SIB 28 02 24

SERVICE ACTION: DOUBLE CLUTCH TRANSMISSION REWORK AT TRANSFER CASE

This Service Information Bulletin (Revision 2) replaces SI B28 02 24 **dated May 2024**.

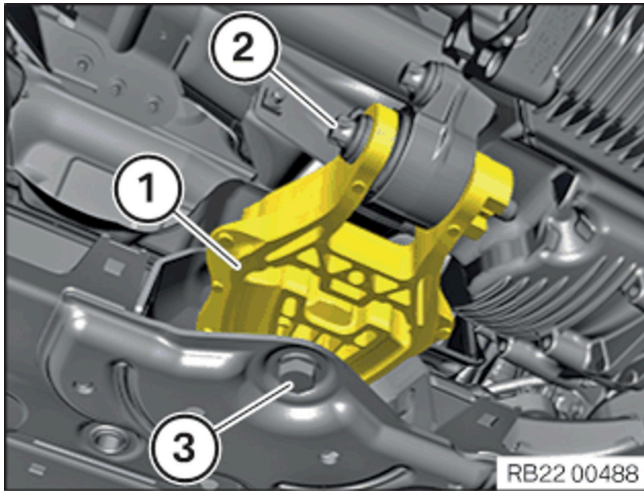
Micro-movements combined with frictional corrosion can increase wear on the longitudinal splined connection between the double clutch transmission (DCT) and the transfer box.

Add spacers at the connection between the DCT and transfer box to decrease micro-movements.

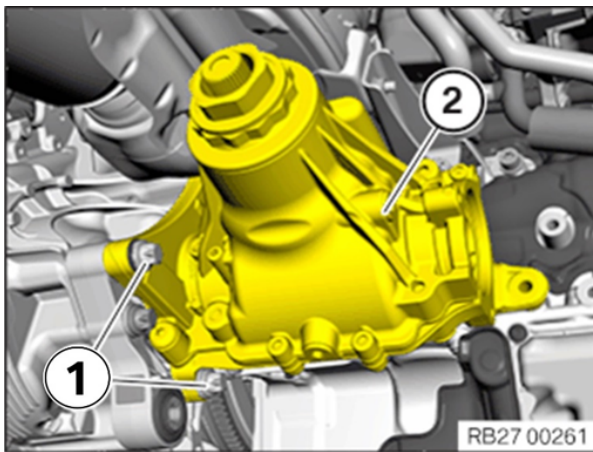
Remove the stabilizer link (1).

Reinstallation: Replace bolts 2 and 3

Tighten to 100 Nm and torque angle 90°

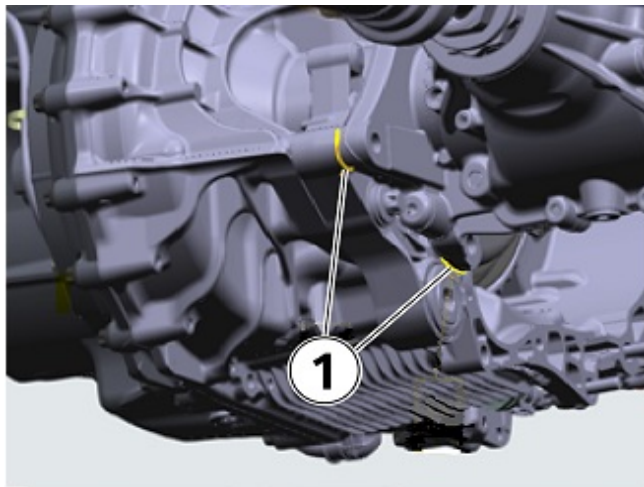
Remove the two bolts (1) on the transfer case.

Reinstallation: Replace both bolts

Tighten to 100 Nm and torque angle 90°

Install washers between the link and transfer case. It may be necessary to slightly push the transfer case to the side to install the washers.
